HOPE CREEK GENERATING STATION
DOCKET NO. 50-354
DRAFT SAFETY EVALUATION REPORT
OPEN ITEM STATUS

Attachment 1 is a current list which provides a status of the open items identified in Section 1.7 of the Draft Safety Evaluation Report (SER). Items identified as "complete" are those for which PSE&G has provided responses and no confirmation of status has been received from the staff. We will consider these items closed unless notified otherwise. In order to permit timely resolution of items identified as "complete" which may not be resolved to the staff's satisfaction, please provide a specific description of the issue which remains to be resolved.

In addition, enclosed for your review and approval (see Attachment 4) are the resolutions to the Draft SER open items, listed in Attachment 3.

FIGURE A-14-11
 RESPONSE SPECTRA COMPARISON,
 INTAKE STRUCTURE AT ELEV. 93' -0",
 E-W, SSE, 2% DAMPING

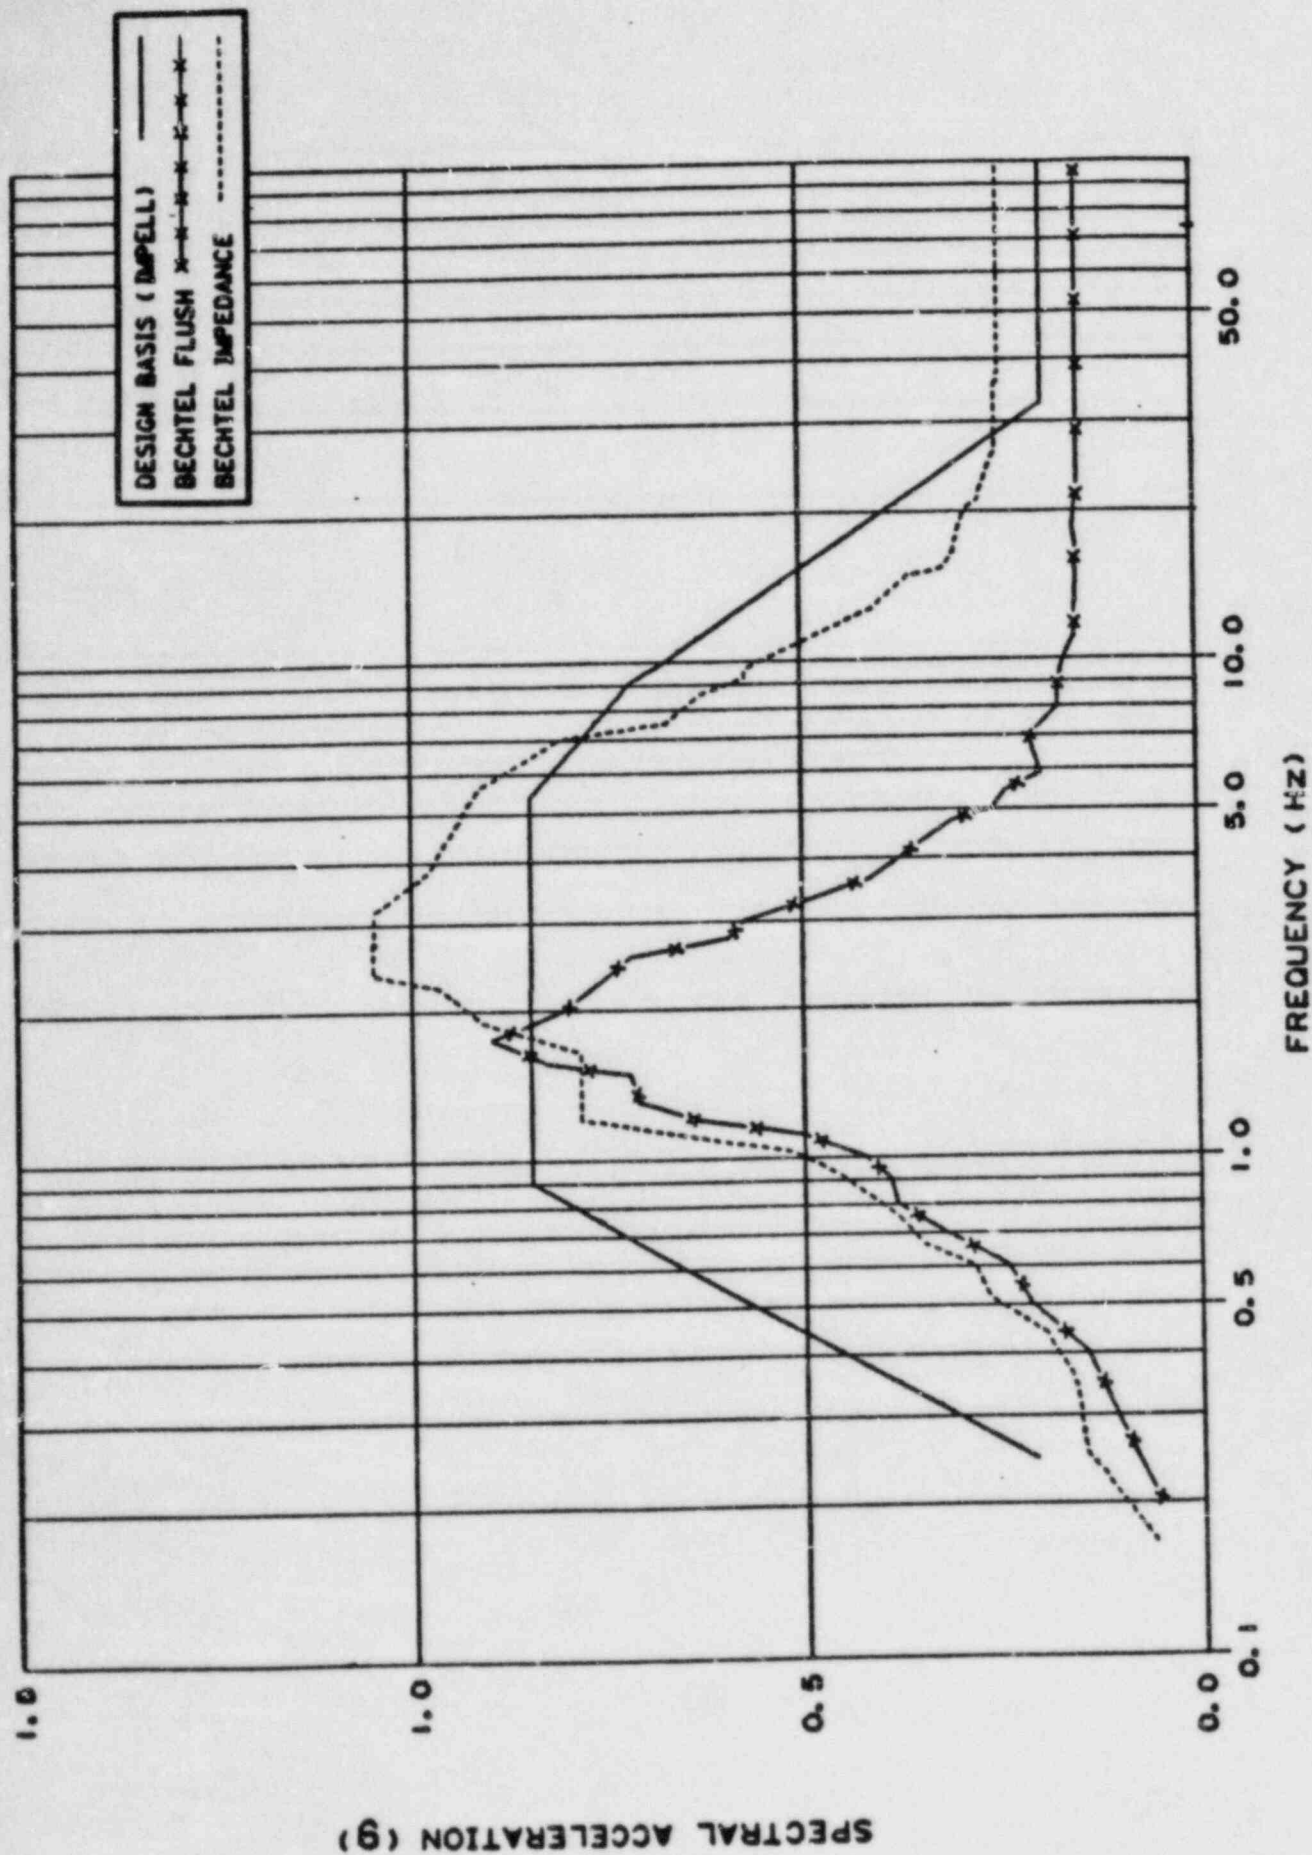
Question: Assess and justify that the current soil modeling for the intake structure adequately accounts for:

Item No.	Key Elevation Ft.	Design Earthquake	Earthquake Direction	Location of Exceedances (Note 1)	Figure No.	Spectral Acceleration (Note 2)	
						Design Basis (g)	Bechtel FLUSH (g)
1	93	SSE	E-W	1.80 Hz.	A-14-11	0.85	0.89
2	114	SSE	E-W	1.30 Hz.	A-14-12	0.84	1.04
3	135	SSE	E-W	1.80 Hz.	A-14-13	1.01	1.17
4	135	SSE	VERT.	3.60 Hz.	A-14-16	1.79	1.81
5	135	SSE	VERT.	18.0 Hz.	A-14-16	1.50	1.59
6	135	OBE	VERT.	4.0 Hz.	A-14-25	1.41	1.44
7	135	OBE	VERT.	18.0 Hz.	A-14-25	1.24	1.30

FIGURE A-13-3
 RESPONSE SPECTRA COMPARISON,
 UNIT 1 REACTOR BUILDING AT ELEV. 102' -0",
 N-S, 55F, 2% DAMPING

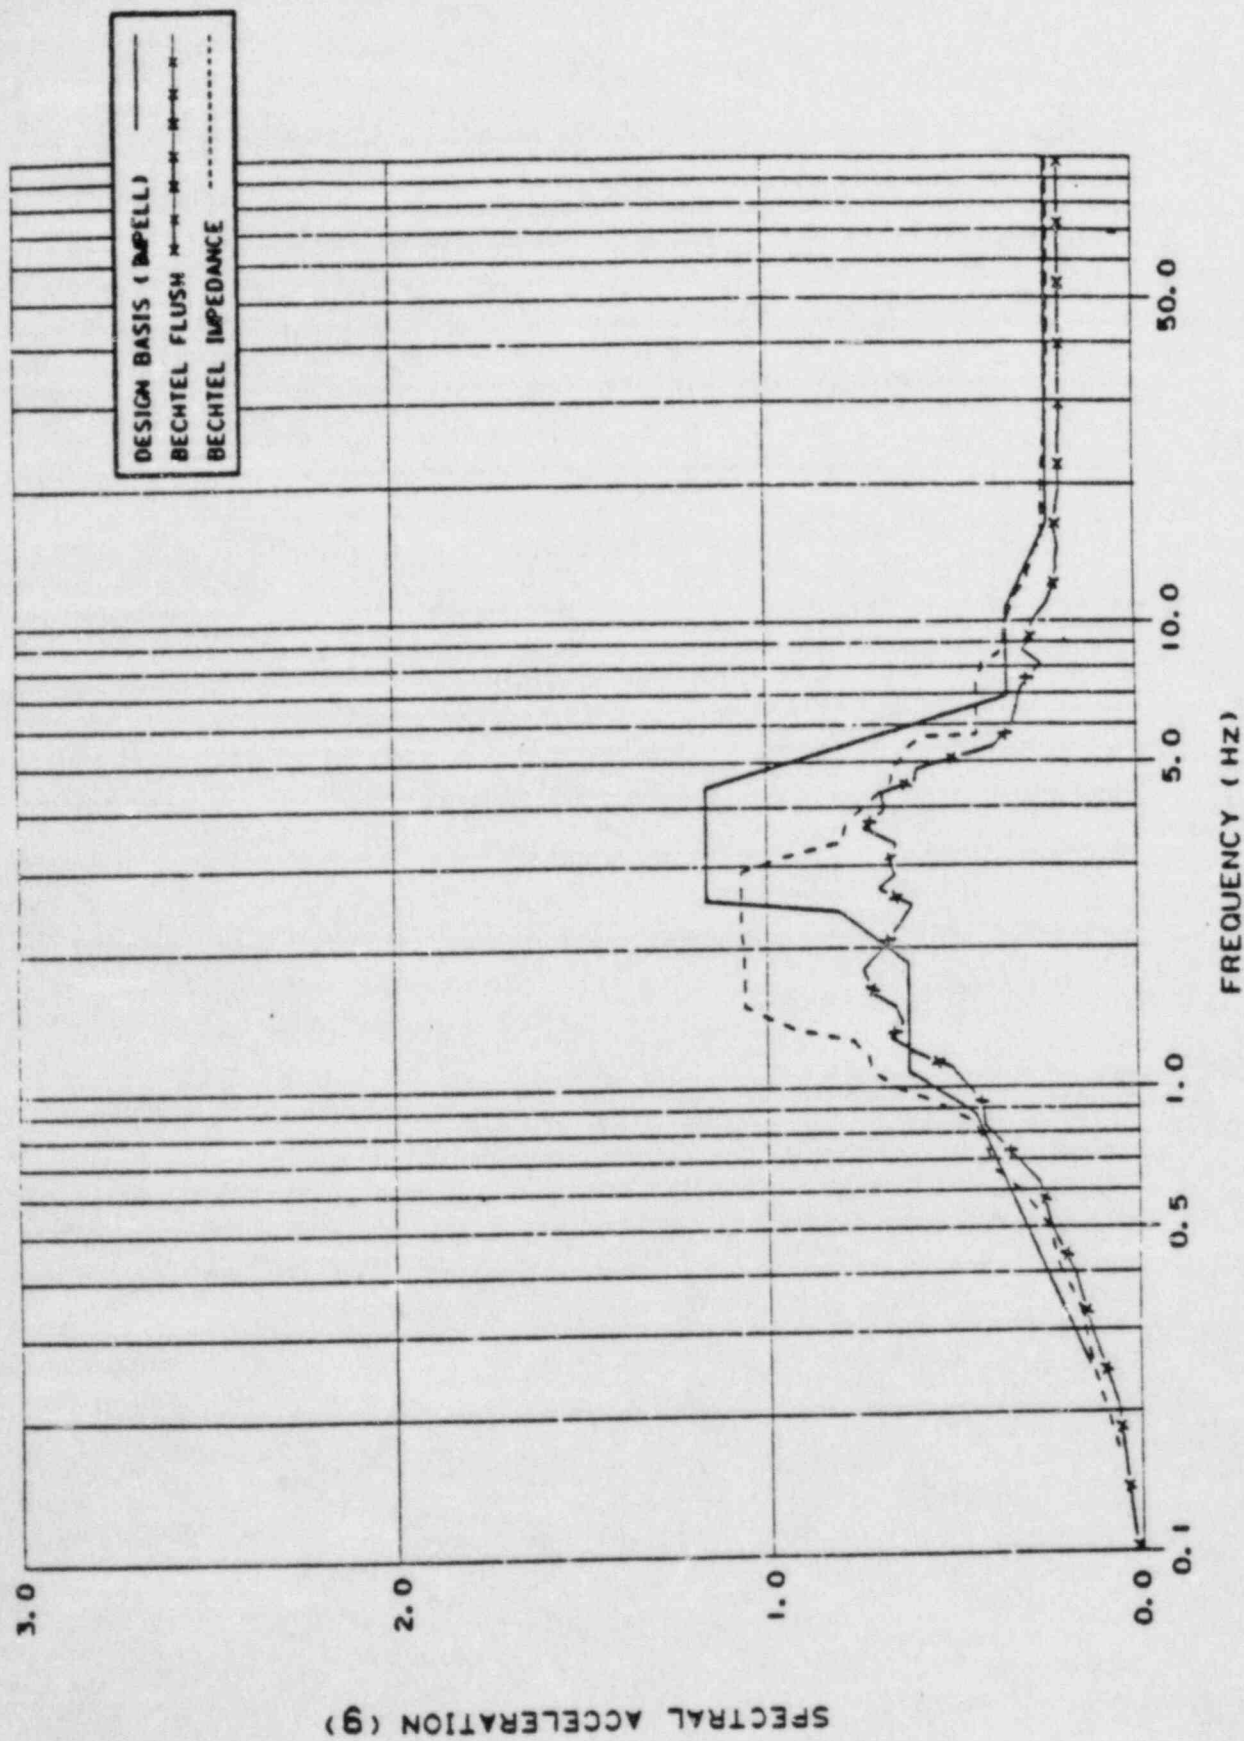
Question: Provide comparison of Bechtel Independent Verification Results with the Design Basis Results.

Building	Key Elevation	Design Earthquake	Earthquake Direction	Locations of Variations (Note 1)	Figure No.	Item No.	Spectral Acceleration (Note 2)	
							Design Basis (g)	Bechtel FLUSH (g)
REACTOR	102	SSE	N-S	1.8 Hz	A-13-3	1	0.62	0.75
	201	SSE	N-S	1.8 Hz	A-13-4	2	1.00	1.22
	54	SSE	Vertical	18.5 Hz	A-13-8	3	1.50	1.75
	102	SSE	Vertical	22.0 Hz	A-13-9	4	1.35	1.68
	201	SSE	Vertical	18.0 Hz	A-13-10	5	2.15	2.45
AUXILIARY	54	SSE	N-S	3.6 Hz	A-13-11	6	1.34	1.56
	54	SSE	E-W	3.0 Hz	A-13-14	7	0.88	1.44
	102	SSE	E-W	3.0 Hz	A-13-15	8	1.10	1.68
	178	SSE	E-W	3.2 Hz	A-13-16	9	1.40	1.92
	102	SSE	Vertical	14.0 Hz	A-13-18	10	1.83	1.95
	178	SSE	Vertical	22.0 Hz	A-13-19	11	1.53	1.85

FIGURE A-16-20
FIXED BASE LUMPED MASS STICK MODEL
OF INTAKE STRUCTURE

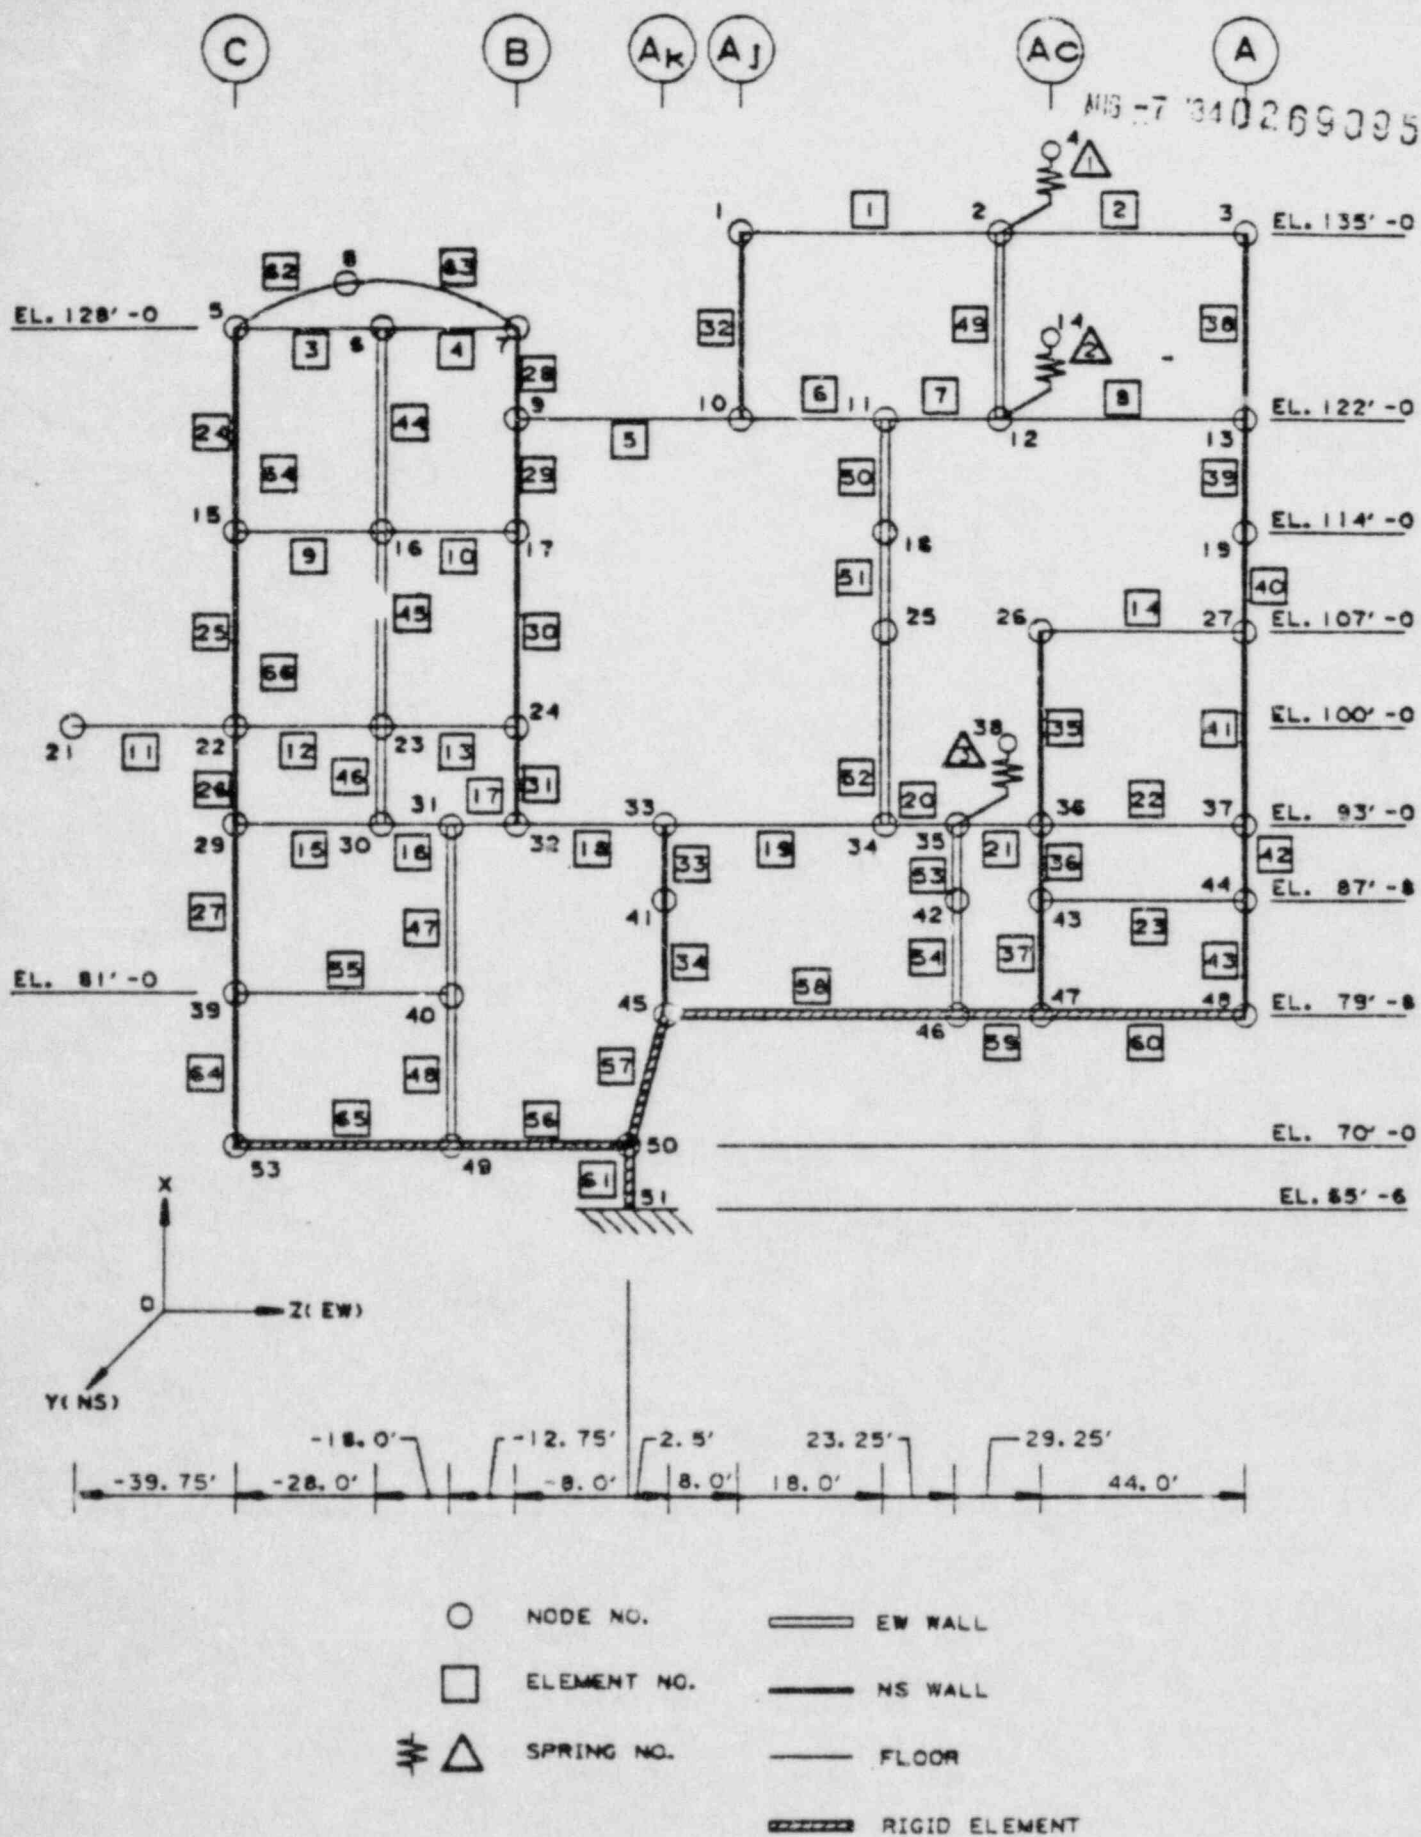
Question: Perform an independent seismic verification analysis (impedance analysis) for the intake structure and compare the results with design basis results. Consider the effects of side boundaries, embedment and the presence of water masses in the analysis.

The impedance approach seismic soil structure interaction analysis of the intake structure (Figure A-16-20) is performed for both the SSE and OBE cases. The foundation soil is assumed to be a uniform linear visco-elastic half space. The weighted average of the final iterated shear moduli of 3,655 ksf (shear wave velocity of 1,007 ft./sec.) and 6,404 ksf (shear wave velocity of 1,333 ft./sec.) respectively, are used in calculating the horizontal SSE and OBE impedance functions. Since the groundwater table is located at elevation 98.0 ft., a compressional wave velocity, V_p , of 4,800 ft./sec/ is used for the vertical analysis. The computed OBE and SSE translational and rocking impedances for the embedded intake structure foundation are given in Tables A-16-6 and A-16-7.
